ITEM FOR ENVIRONMENTAL BOARD AGENDA

**NAME & NUMBER
OF PROJECT:** ILES BOAT DOCK
SP-2014-0212DS

Project: Iles Boat Dock- SP-2014-0212DS
Ordinance Standard: Land Development Code Section 25-8-281(C)(2)(b)
Variance Request: To allow construction of a boat dock within a canyon rimrock Critical Environmental Feature buffer.

SUBJECT: 2415 Big Horn Drive, SP-2014-0212DS

BACKGROUND

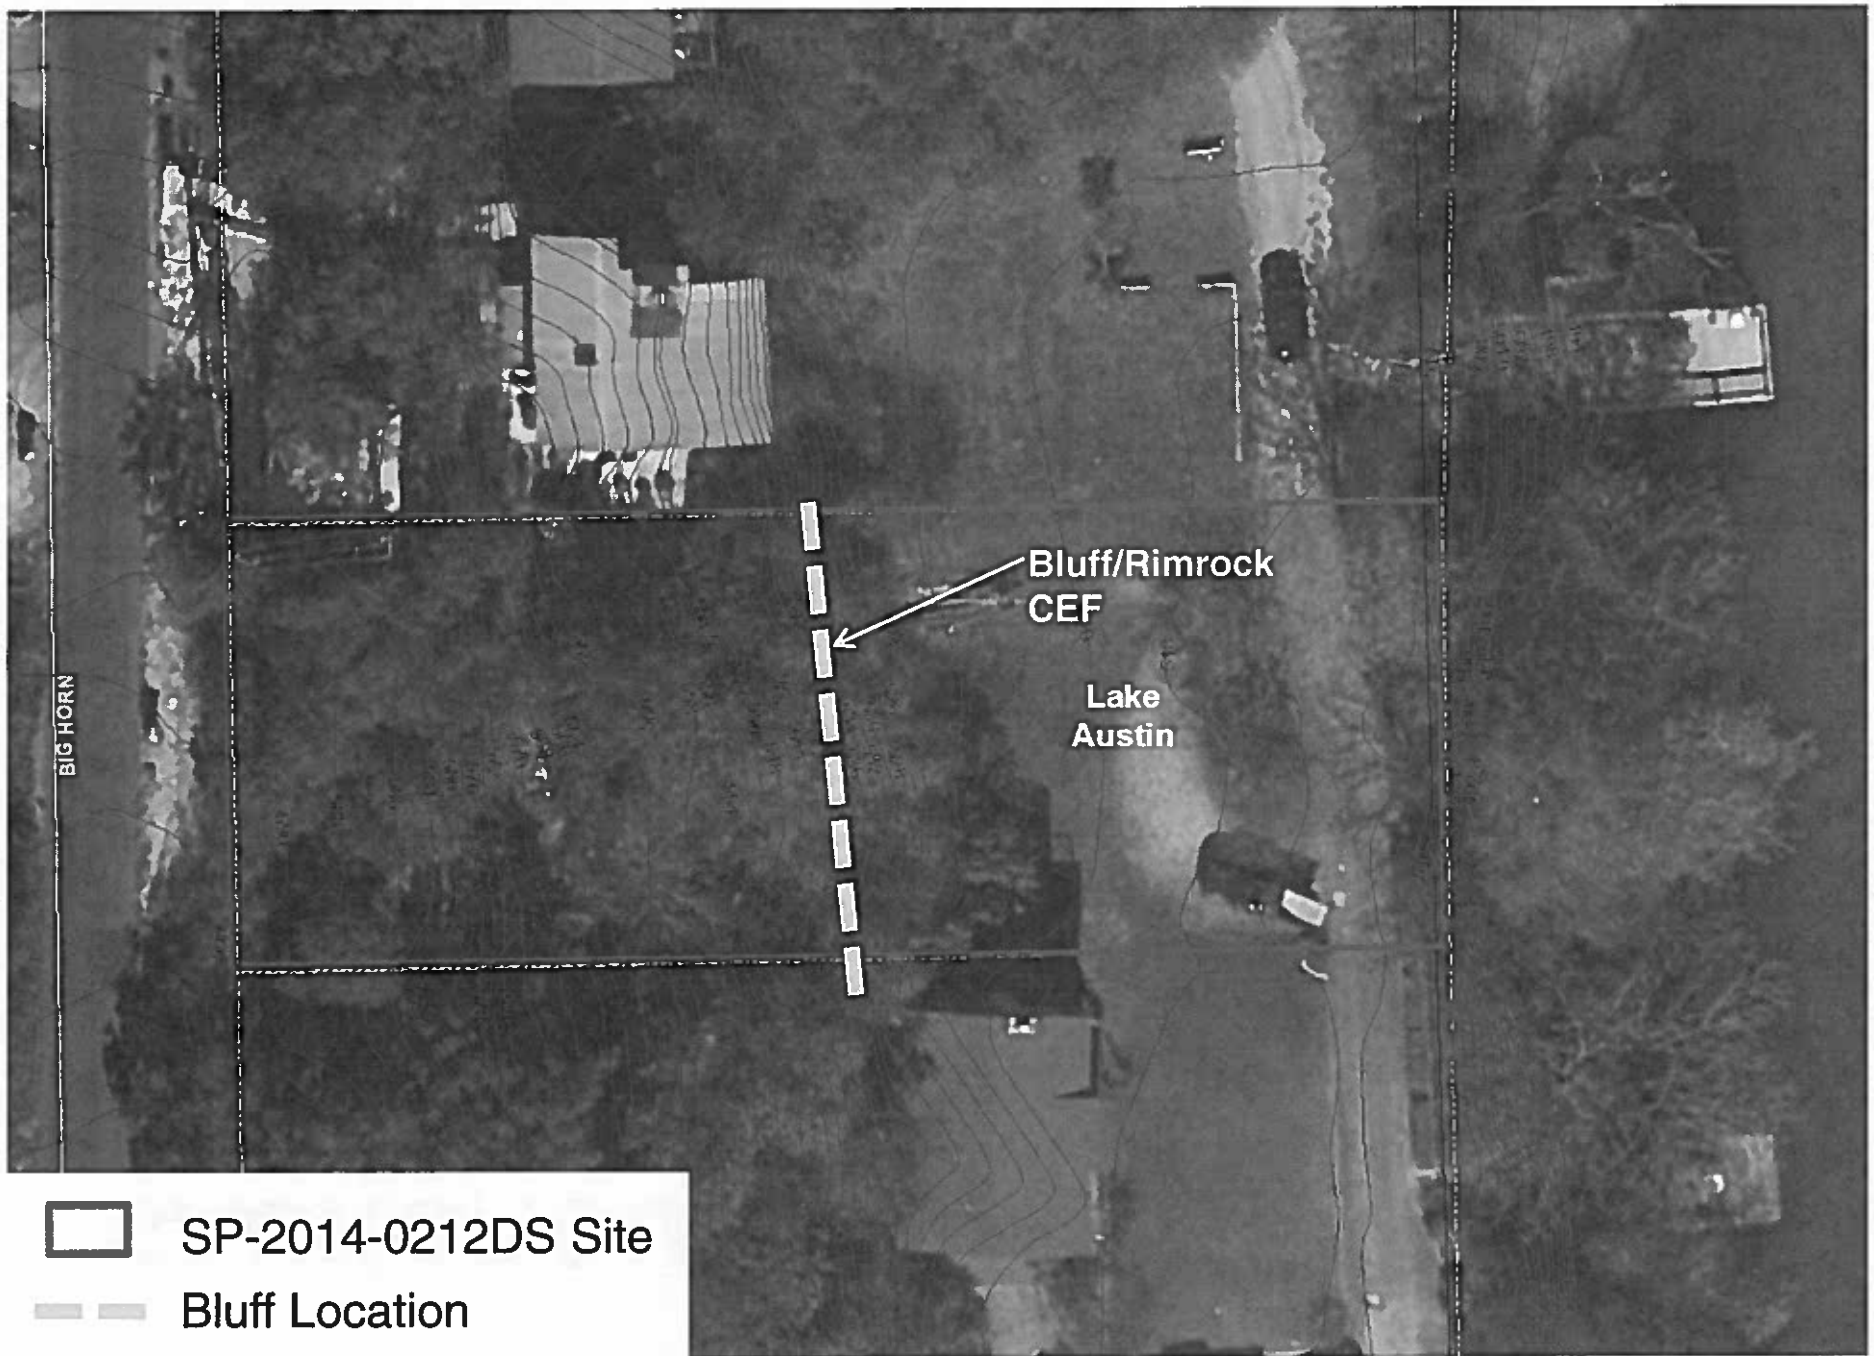
- **Undeveloped single family lot.**
- **Shoreline consists of natural rocky slope.**
- **Applicant proposes only to build a new 15' wide dock and associated stairs.**
- **Resulting development is entirely downstream of the Critical Environmental Feature.**
